**STATE OF TENNESSEE
DEPARTMENT OF TRANSPORTATION**

INSTRUCTIONAL BULLETIN NO. 21-20

Regarding Various Revised, New and Voided Standard Drawings

Effective May 13, 2022 letting (March 2, 2022 Turn-in), the following Standard Drawings have been revised or are new. In addition, the Roadway Design Guidelines Chapter 7 – Item Numbers, Sections 7-611.00, Manholes, Catchbasins, Inlets and Pipe End Walls, and Section 7-705.00, Guardrails, of the Roadway Design Guidelines has been modified to reflect any changes to or new item numbers in the Standard Drawings of this Instructional Bulletin.

SINGLE SLOPE BARRIER WALL FOR GRADE SEPARATED MEDIAN

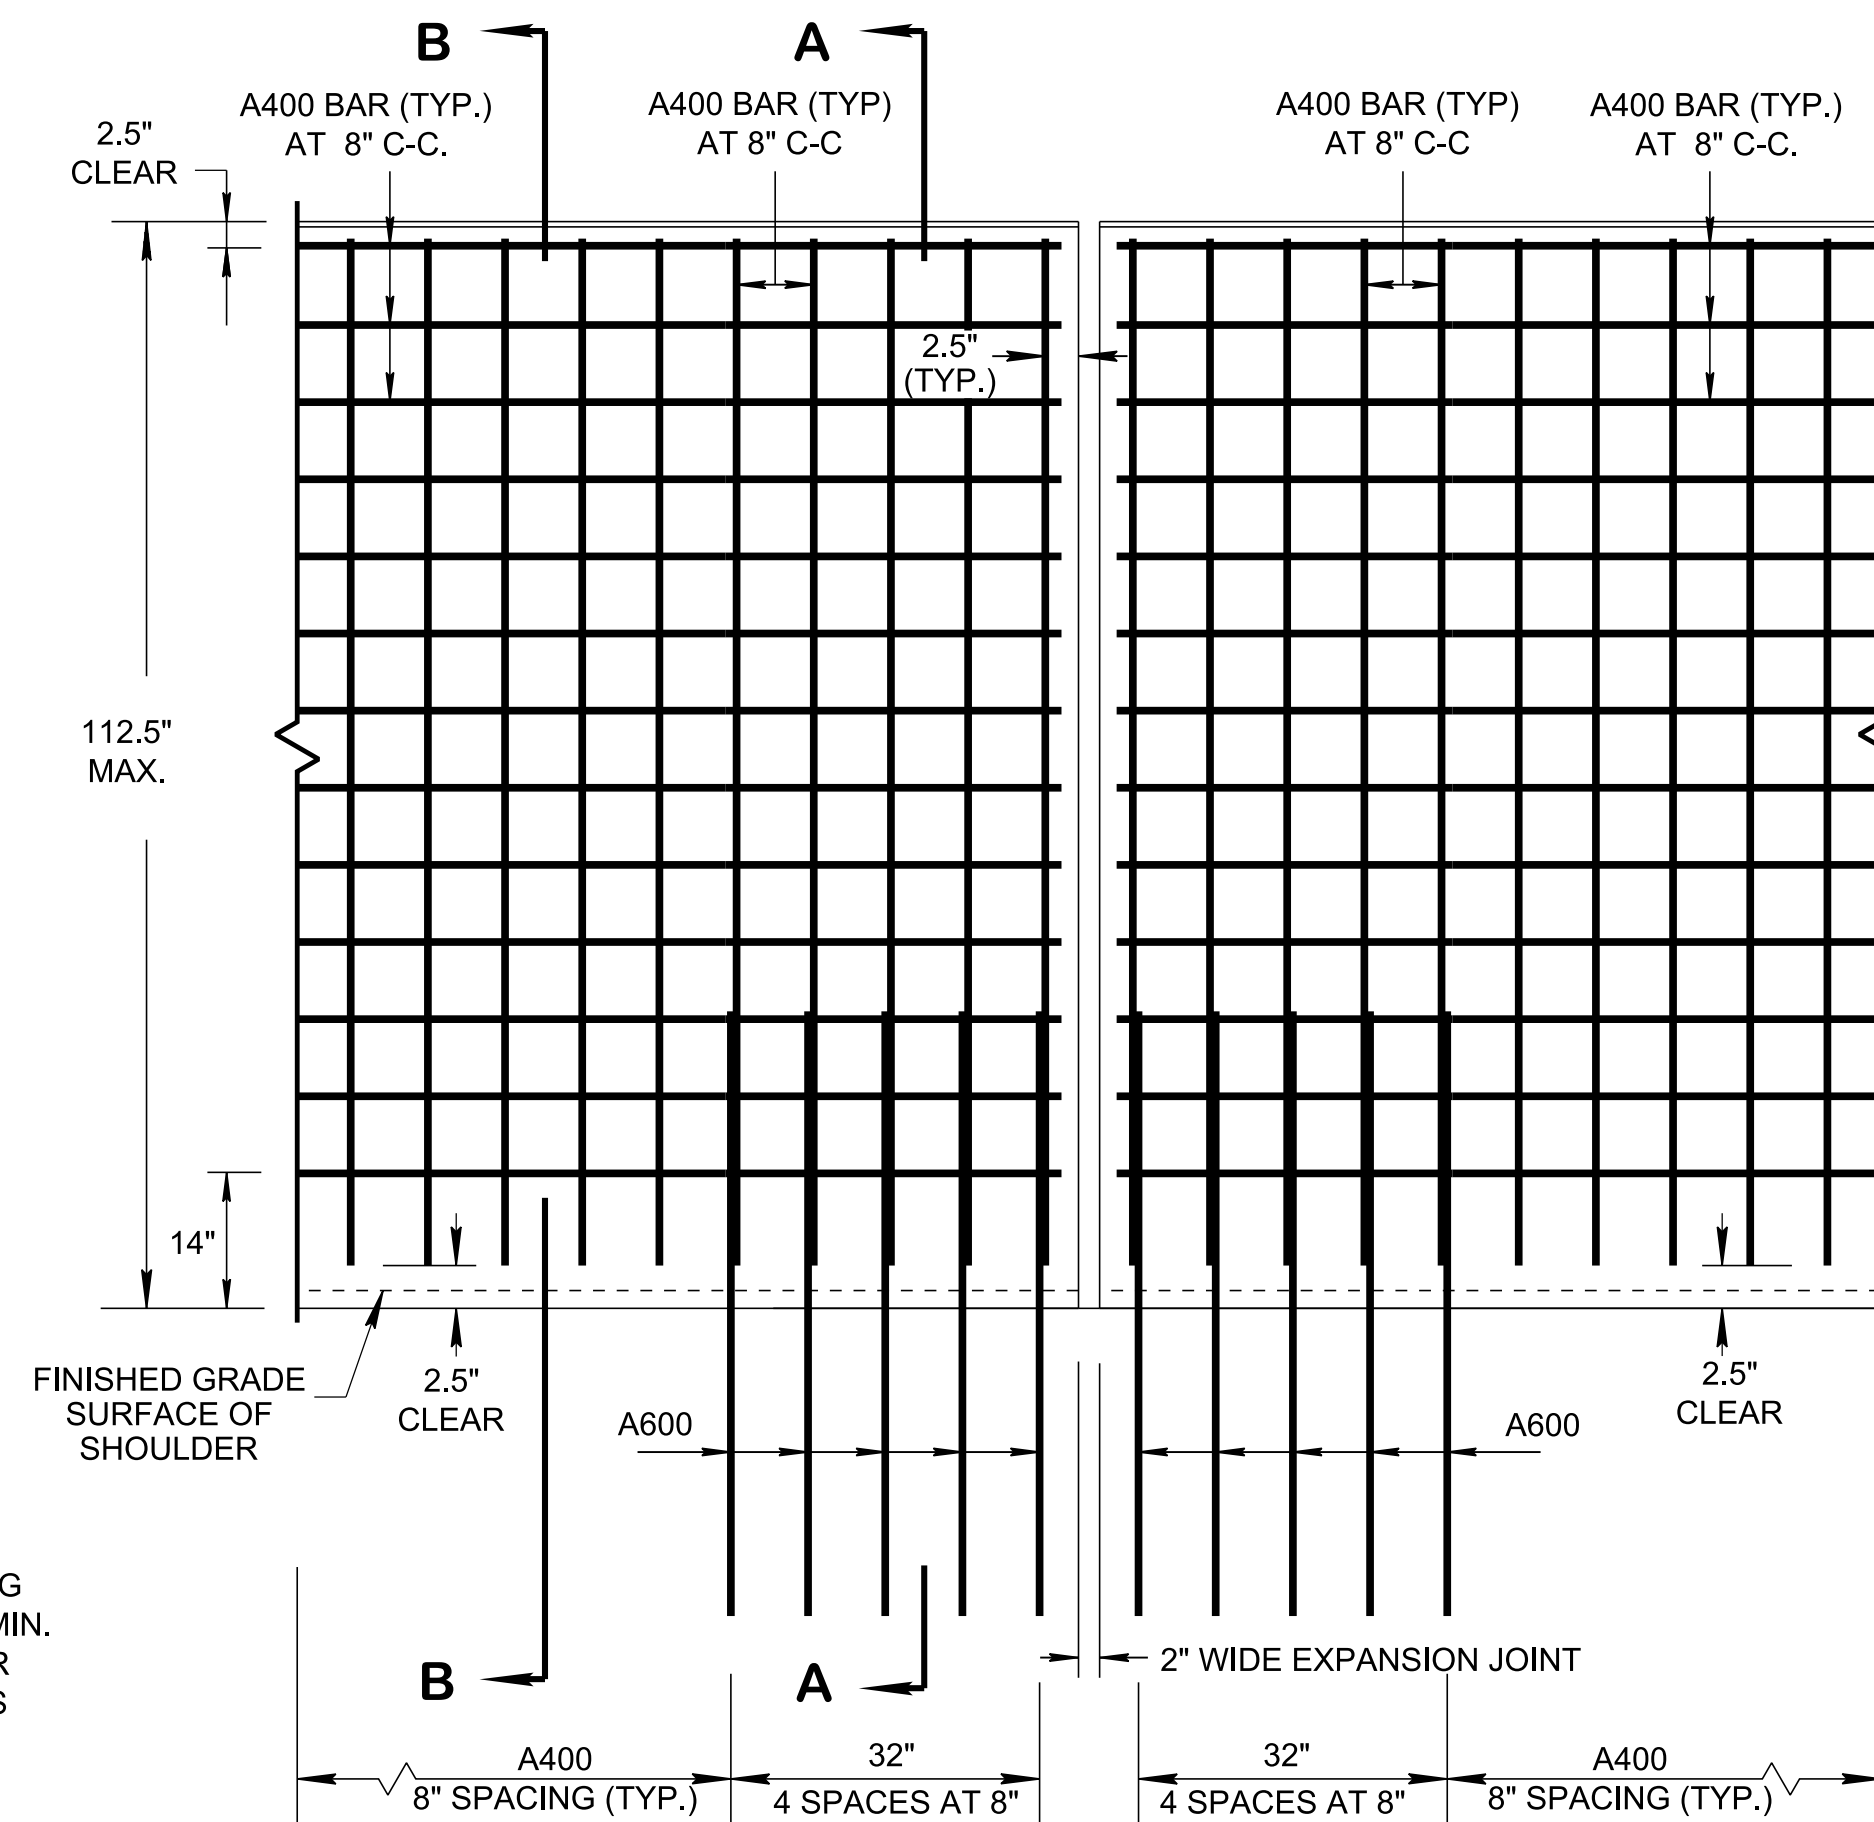
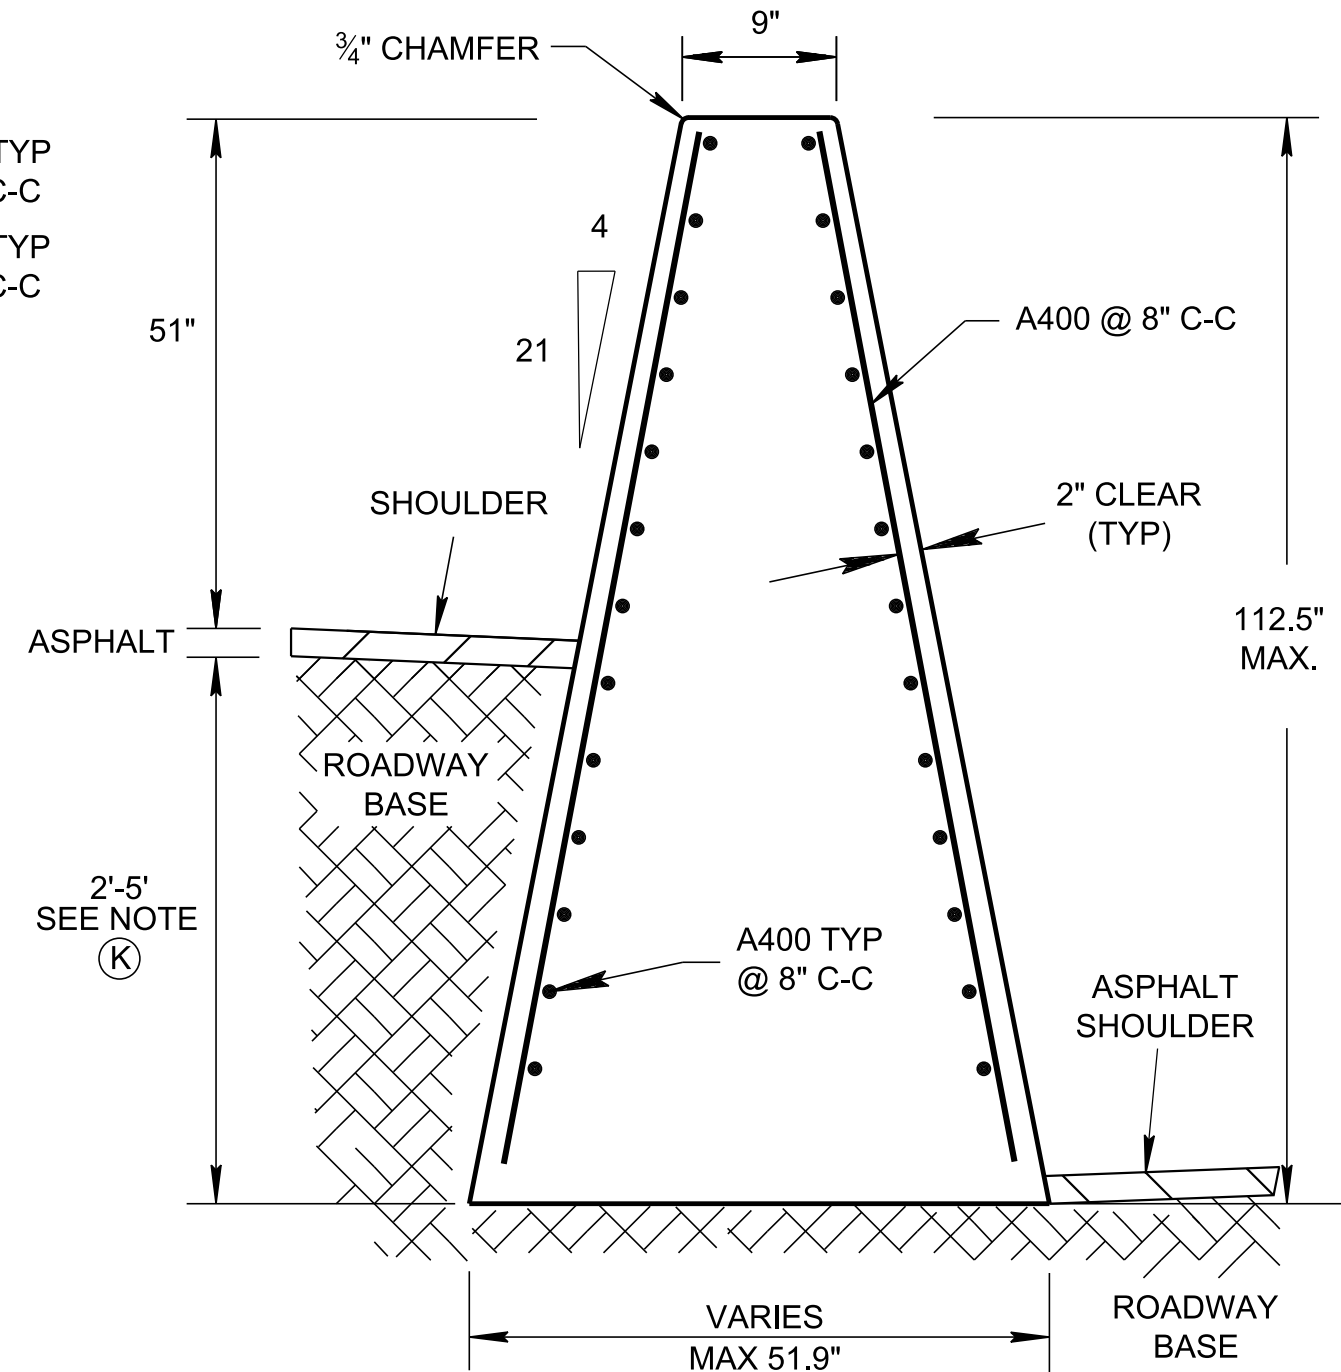
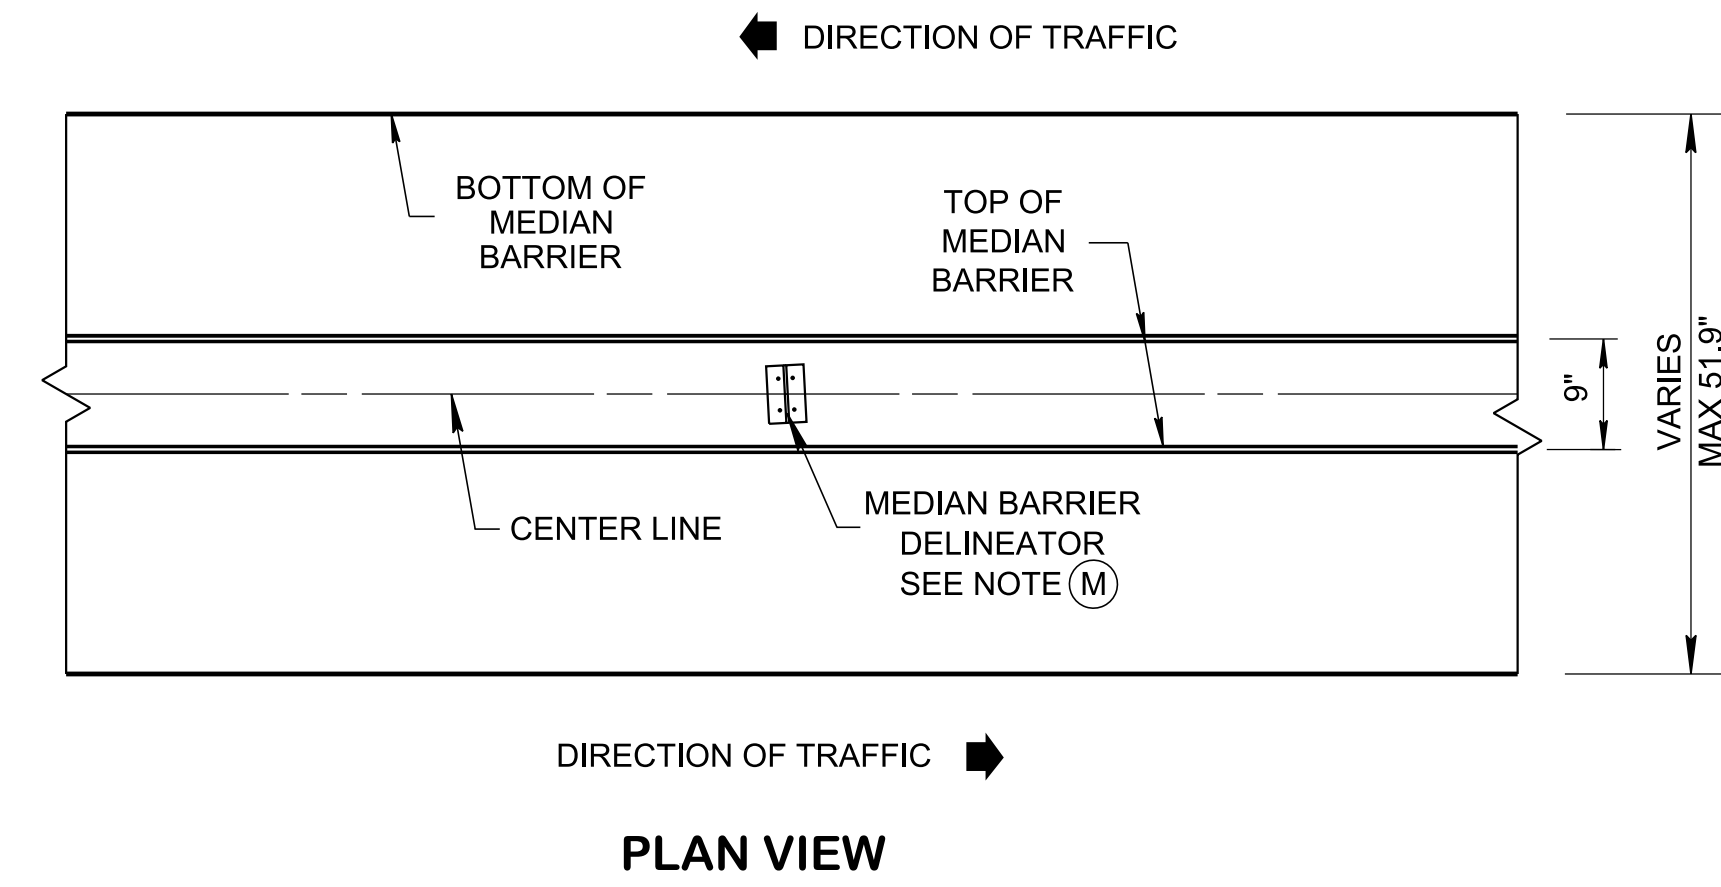
REV. 7-16-13: ADDED NOTES (K) AND (L) AND ADDED ALTERNATIVE.
 REV. 05-01-20: REDREW SHEET.
 REV. 06-15-21: REVISED SECTIONS AND REDREW THE REINFORCEMENT DETAIL. REMOVED DELINEATOR MOUNTING DETAIL AND NOTES. ADDED PLAN AND GENERAL NOTE (M). REVISED GENERAL NOTE (A).
 REV. 10-29-2021: REVISED DELINEATOR STANDARD DRAWING NUMBER ON GENERAL NOTE (M).

- (M) REFER TO STANDARD DRAWING T-M-18A FOR MEDIAN BARRIER DELINEATOR DETAILS AND NOTES. THE COST OF FURNISHING AND INSTALLING MEDIAN BARRIER DELINEATORS SHALL BE INCLUDED WITH THE BID PRICE FOR CONCRETE MEDIAN BARRIERS.
